RE: Copy of Approved CM Construction Report  
Ciba Site – Glens Falls, NY

RE: **Response To Review Comments**  
**Corrective Measures Implementation Construction Documentation Report**  
**Ciba Site, Glens Falls, New York**

## **Response To Review Comments (NYSDEC Letter Dated February 8, 2005)**

DRAWING No.:  
1/1

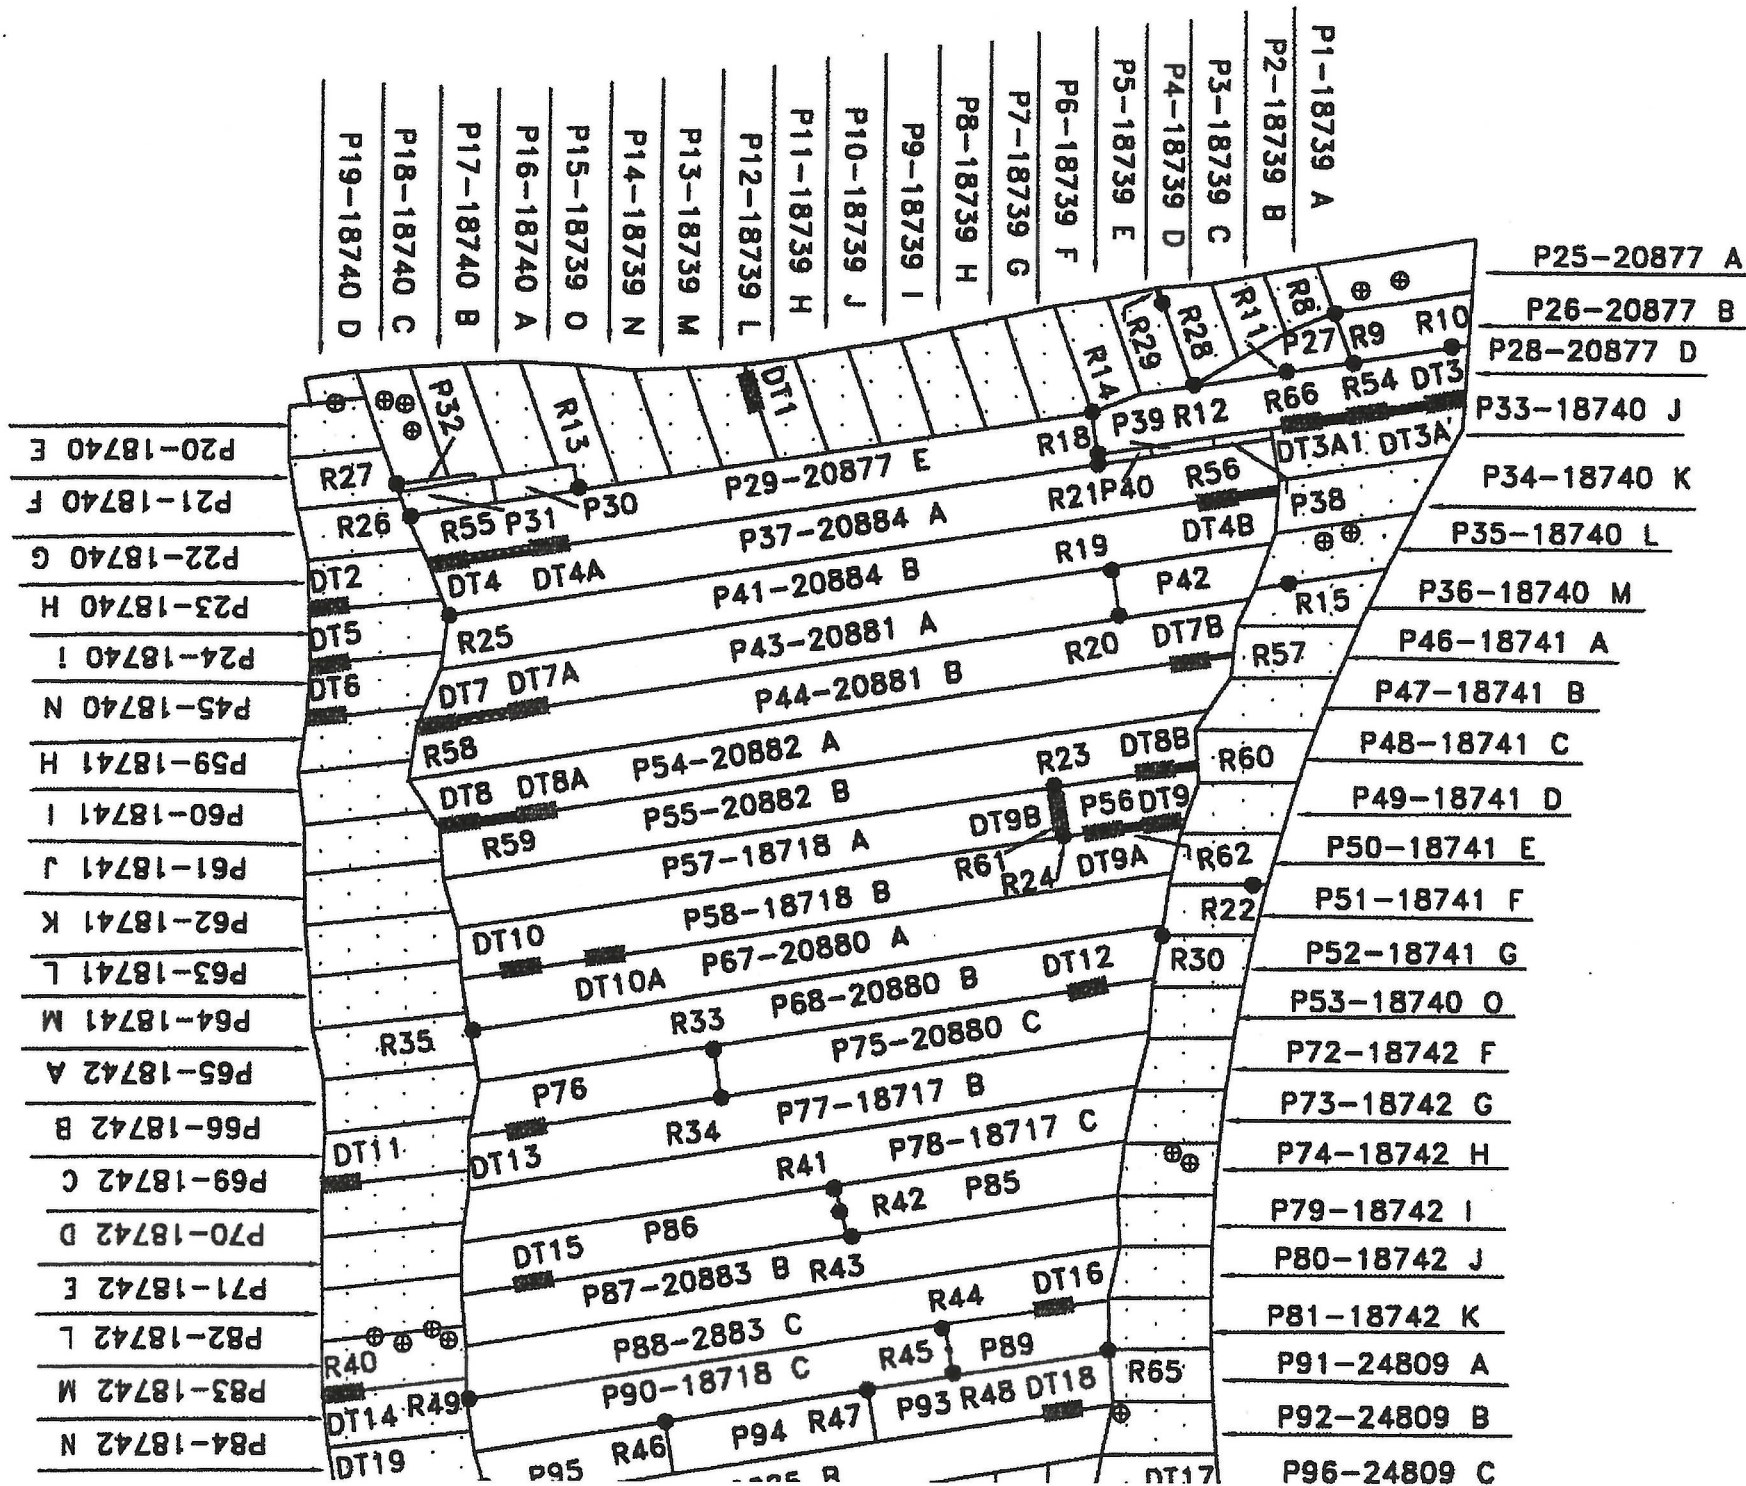
5. As-built drawings showing the layout and orientation of the geosynthetic clay liner (GCL) have not been included in this submission. Please provide these drawings.

***GCL panels were laid parallel to membrane panels shown on Drawing 1 (on CD and also attached). No separate drawing prepared for GCL layer as it was not required by construction specifications.***

- No GCL as-built drawing was required in the specification 02233. Solmax has not built this drawing during installation process.
